BEFORE THE PUBLIC UTILITIES COMMISSION
OF THE STATE OF CALIFORNIA

Application of Pacific Gas and Electric Company (U 39 M) for Authority, Among Other Things, to Increase Rates and Charges for Electric and Gas Service Effective on January 1, 2023.	Application 21-06-021
NOT CONSOLIDATED	
Application of Pacific Gas and Electric Company (U 39 M) to Submit Its 2024 Risk Assessment and Mitigation Phase Report.	Application 24-05-008
NOT CONSOLIDATED	
Application of Pacific Gas and Electric Company (U 39 M) for Authority, Among Other Things, to Increase Rates and Charges for Electric and Gas Service Effective on January 1, 2027.	Application 25-05-009

**COMMENTS OF THE PUBLIC ADVOCATES OFFICE
ON PACIFIC GAS AND ELECTRIC COMPANY'S 2024 RISK
SPENDING ACCOUNTABILITY REPORT**

September 29, 2025

Figure 1: PG&E’s Overhead Conductor Replacement Completion 2020-2024^{14, 15}

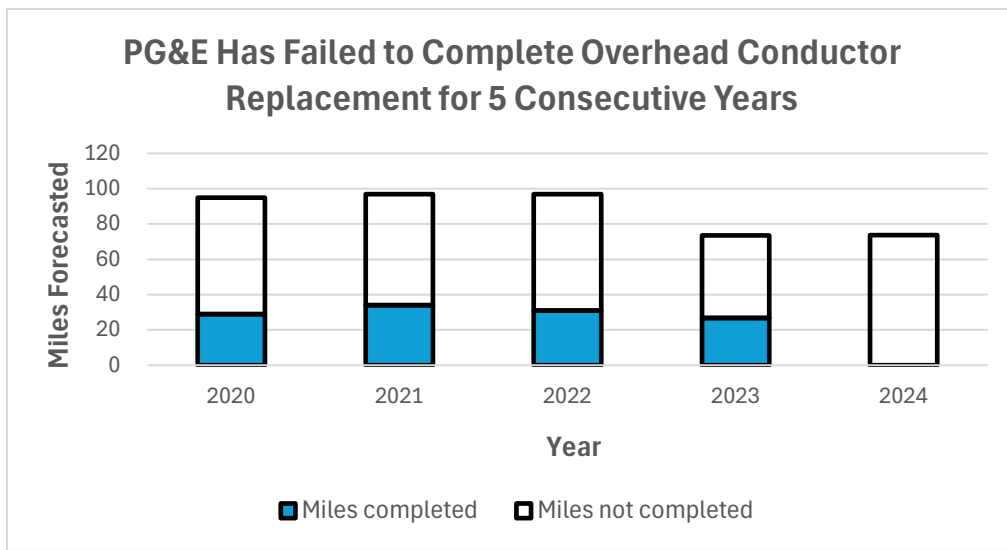
PG&E continues to fall behind in completing its Commission-approved Overhead Conductor Replacement,⁶ a necessary program to replace deteriorated overhead conductor that may cause electrocution, reliability or wildfire ignition hazard.⁷ Further, the Overhead Conductor Replacement that PG&E has completed is not in alignment with its own asset management standards, as highlighted by PG&E's Independent Safety Monitor.⁸ PG&E is simultaneously experiencing elevated instances of wire-down events, as shown in Figure 3 below. These present an immediate electrocution or wildfire ignition hazard to the public and are likely a direct consequence of its failure to timely replace its overhead conductor, as shown in Figure 2 below.⁹ Meanwhile, PG&E continues to overspend on its Commission-approved Routine Emergency Replacement program (as shown in Figure 4 below), which includes replacement of broken conductors.¹⁰

In light of the immediate and ongoing safety hazards to the public caused by PG&E's failure to replace overhead conductor as well as PG&E's resultant cumulative overspending on emergency work by millions of dollars, Cal Advocates urges the Commission to:

- Require PG&E to file a corrective action plan to complete its Commission-approved Overhead Conductor Replacement work and align its Overhead Conductor Replacement program with its own asset management standards.
- Institute a broader oversight process to ensure that PG&E catches up on its incomplete safety and reliability work or justify why such work is no longer needed.

Figure 3: PG&E’s Wires Down Events 2015-2024 (Excluding Major Event Days)²⁹

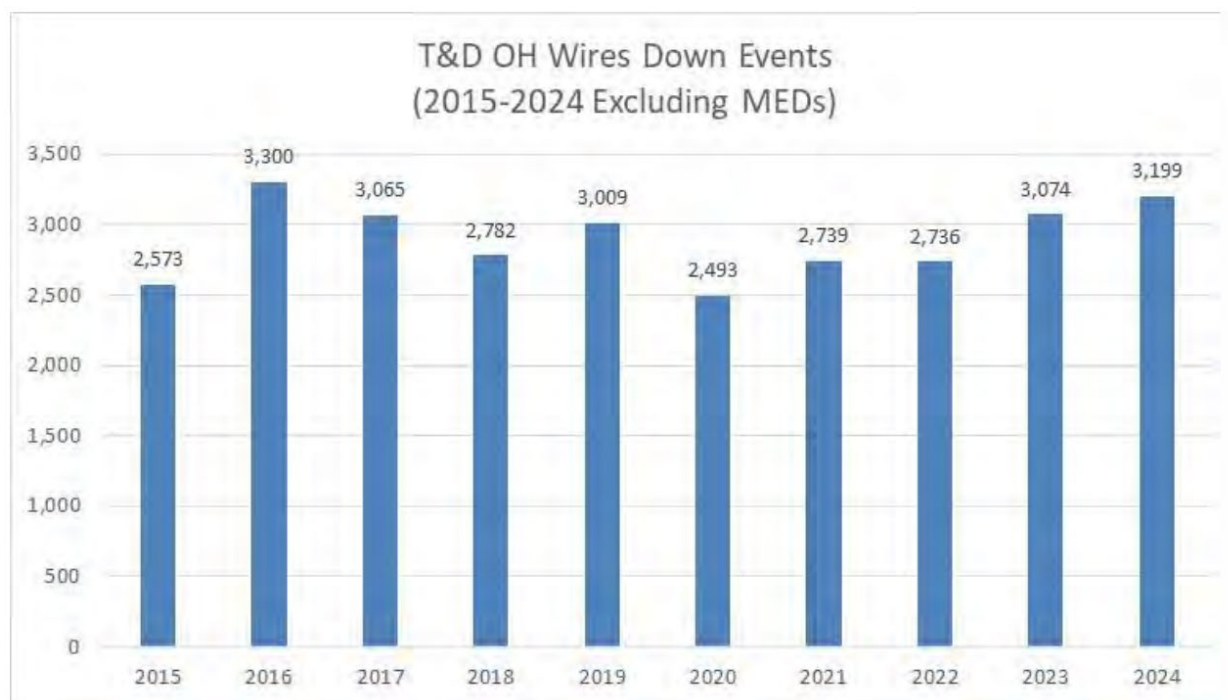
Wire-down events continue to be a significant problem for PG&E. PG&E's 2024 Safety Performance Metrics report shows that for the last four years PG&E has had more wire-down events annually than it did in 2012, with 3,199 such events occurring in 2024.²⁸ This is demonstrated in Figure 3 below.

The Commission should require PG&E to file a corrective action plan to mitigate the immediate and ongoing safety risk from deteriorated overhead conductor and associated wire-down events and ensure that PG&E is adequately maintaining its system in conformance with its own standards. This plan should include the following components:

- a plan and schedule (with start date, completion date, and intermediate steps with corresponding dates) for completing its Commission-approved Overhead Conductor Replacement
- a plan and schedule (with start date, completion date, and intermediate steps with corresponding dates) for accelerating its overhead conductor replacement rate to, at a minimum, conform with its own targeted age-base for its assets, as highlighted by the PG&E Independent Safety Monitor.
- a plan and schedule (with start date, completion date, and intermediate steps with corresponding dates) for decreasing its overhead wire-down events as a result of the above two actions and any others PG&E may take.

Figure 4: PG&E’s Routine Emergency Replacement Spending 2020-2024^{32, 33}

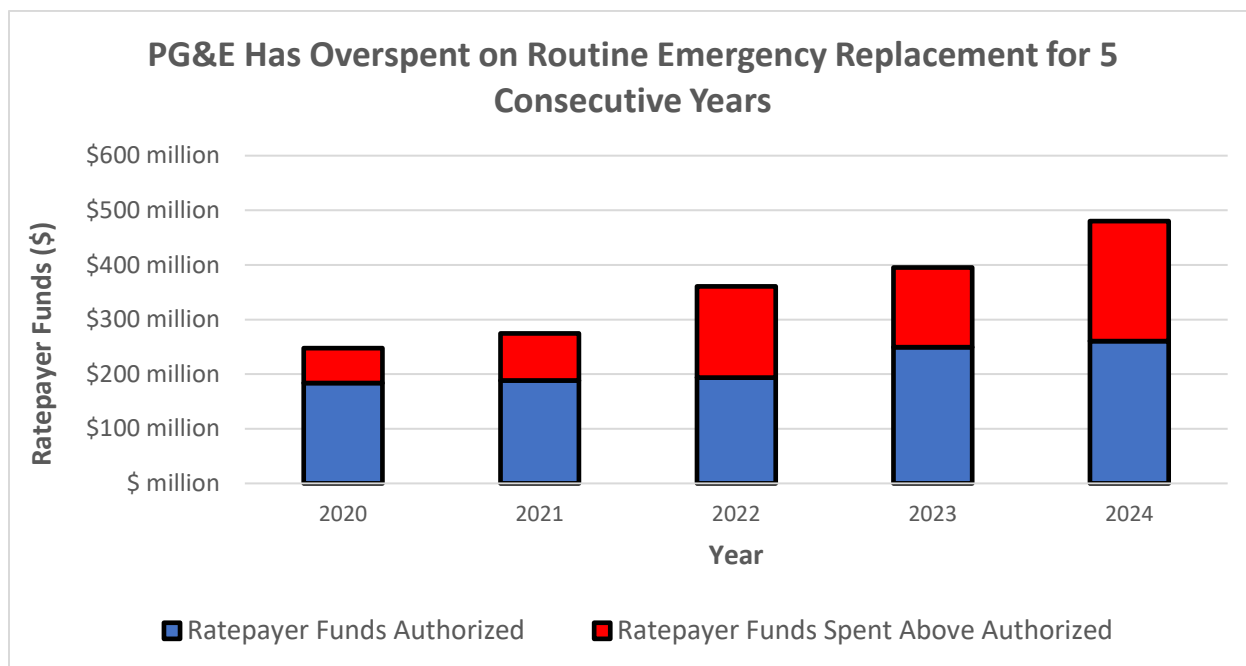
During these same years where PG&E has failed to timely complete its Overhead Conductor Replacement and experienced elevated instances of wire-down events, PG&E has significantly overspent on its Routine Emergency Replacement program, which includes replacement of Overhead Conductor.³⁰ As Figure 4 below demonstrates, PG&E’s overspending has grown over the last five years, with PG&E overspending by approximately \$220 million in 2024.³¹

In a data response to Cal Advocates, PG&E stated that overhead conductor was partially responsible for its overspending on Routine Emergency Replacement:

PG&E experienced an **increase in failures of covered secondary conductor** due to cracking, corrosion, and abrasion. These failures are an ignition risk to Customer Equipment and Property as well as Wildland Fire Risk, and are required to be immediately remediated. (bold added)³⁴
